Subject Review of Info & Comments Lot 101 on S 102 967
Summary.

DRAFT SITE MANAGEMENT PLAN - LOT 101 ON SP 102967 (FORMER NEW FARM POWER STATION SITE).

Re: Newfarm Powerstation: Draft Site Management Plan, - Lot 2 and a Portion of Lot 3 on Registered Plan (RP) 210504, Lot 1 and a Portion of Lot 2 on RP 53157

Identified areas of fill

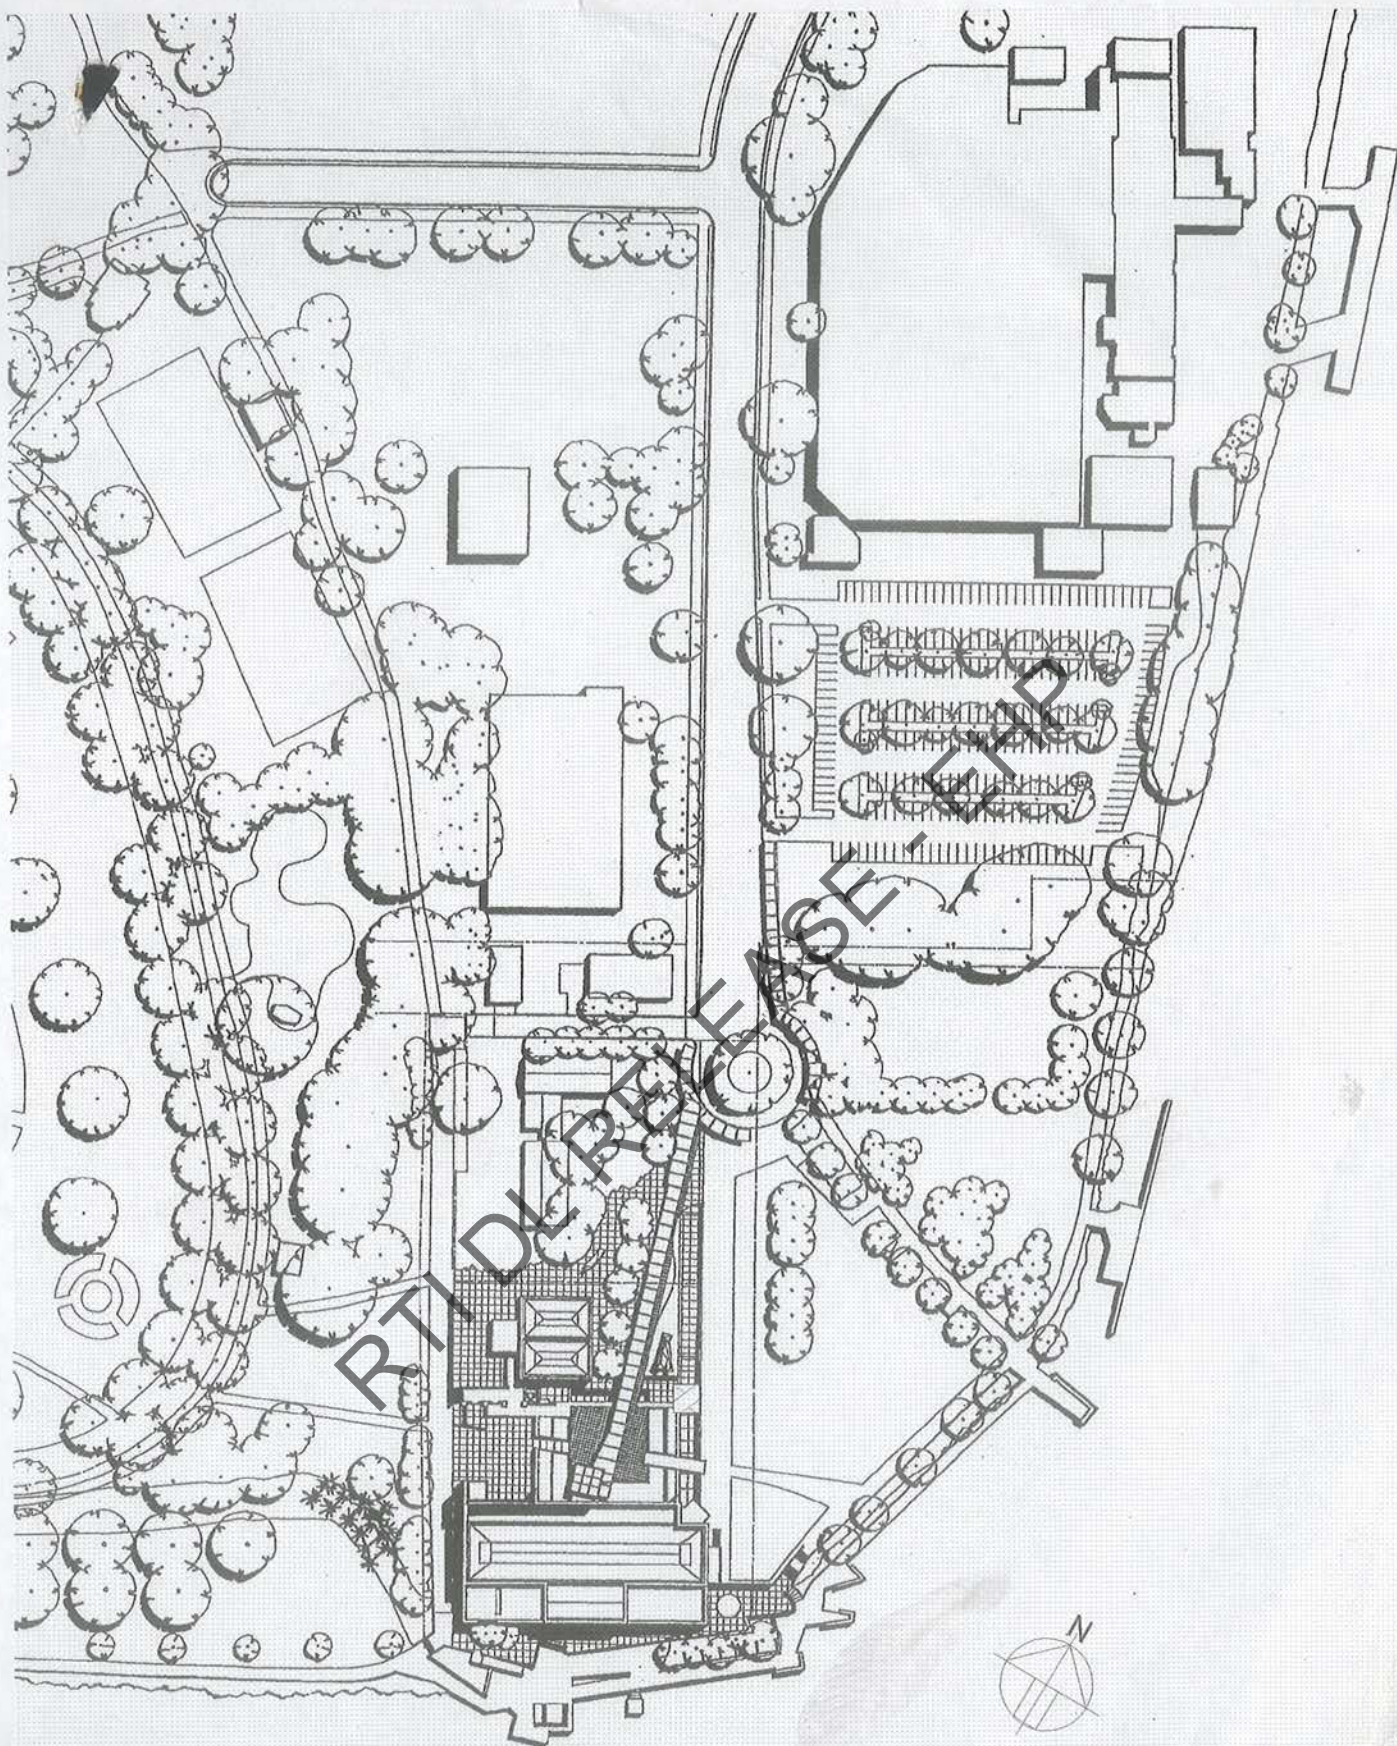
- need lot on plan on maps.
- figure 2 is misleading as contamination across the site has not been definitively quantified due to nature of fill across the site.
